EPC PACKAGE FOR LARA SUPER THERMAL POWER PROJECT, STAGE-II (2x800 MW)
Amendment No. 02 to Technical Specifications Section-VI of Bidding Document No.: CS-9587-001R-2

Doc. No.: CS-9587-001R-2-TECH AMDT- 02	LARA SUPER THERMAL POWER PROJECT STAGE-II (2X800 MW)	Amendment No. 02 to Technical Specifications Section-VI
--	---	--

This document is the property of NTPC LIMITED. No part of this document will be reproduced by any means without the written permission.

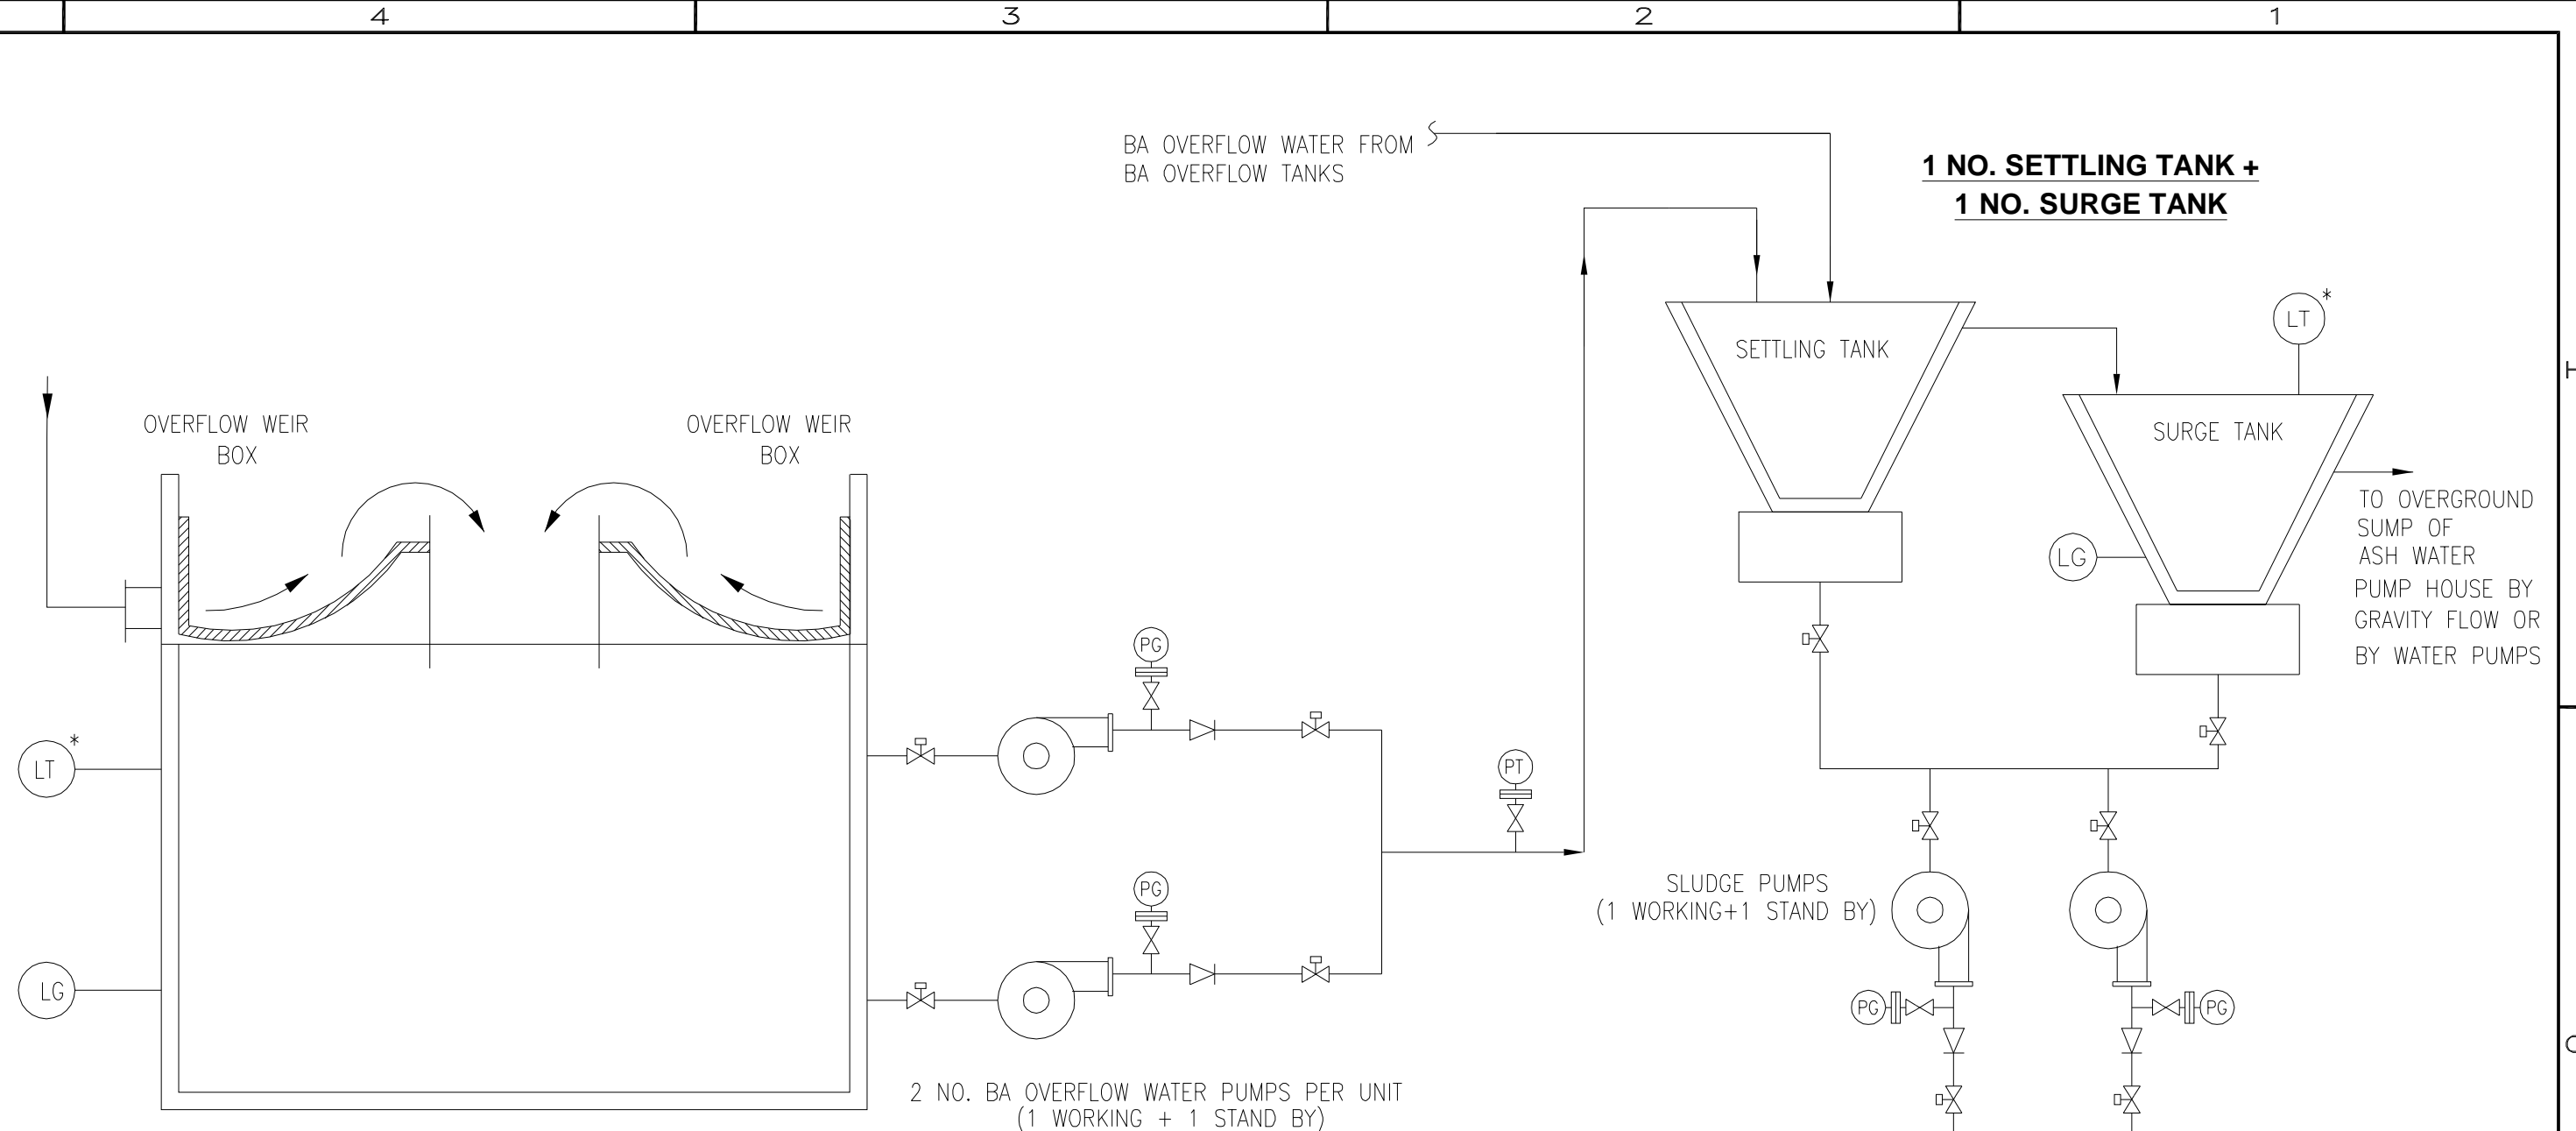
S. No.	SPECIFICATION REFERENCE				Instead of	Read as
	Section / Part	Sub-Section	Clause No.	Page No.		
MH-1	VI/PART-E				9587-001(R)-POM-A-002 R0 9587-001(R)-POM-A-025 R0 9587-001(R)-POM-A-026 R0 9587-001(R)-POM-A-027 R0 9587-001(R)-POM-A-028 R0 9587-001(R)-POM-A-029 SH1 R0 9587-001(R)-POM-A-029 SH2 R0	9587-001(R)-POM-A-002 R1 9587-001(R)-POM-A-025 R1 9587-001(R)-POM-A-026 R1 9587-001(R)-POM-A-027 R1 9587-001(R)-POM-A-028 R1 9587-001(R)-POM-A-029 SH1 R1 9587-001(R)-POM-A-029 SH2 R1
MH-2	VI/PART-A	IIA-15	2.03.00	5 OF 8	Space and interface provision for one (1) additional stream of Truck Tippler, BRU/Surface Feeder and Bucket Elevator shall be kept for future eventuality.	Space and interface provision for one (1) additional stream of Truck Tippler, BRU/Surface Feeder and Bucket Elevator shall be kept for future eventuality considering following as a minimum a. Ramp to be constructed considering for both truck tippler. b. BRU station / building to be sized considering two no's BRU unit & feeding system. c. Bucket elevator supporting arrangement shall be considered from silo for two no's bucket elevators. d. Silo is to be designed for two streams of conveyor feeding. (One is for St-II + One future stream) e. Handling arrangement to be designed considering future equipment also.
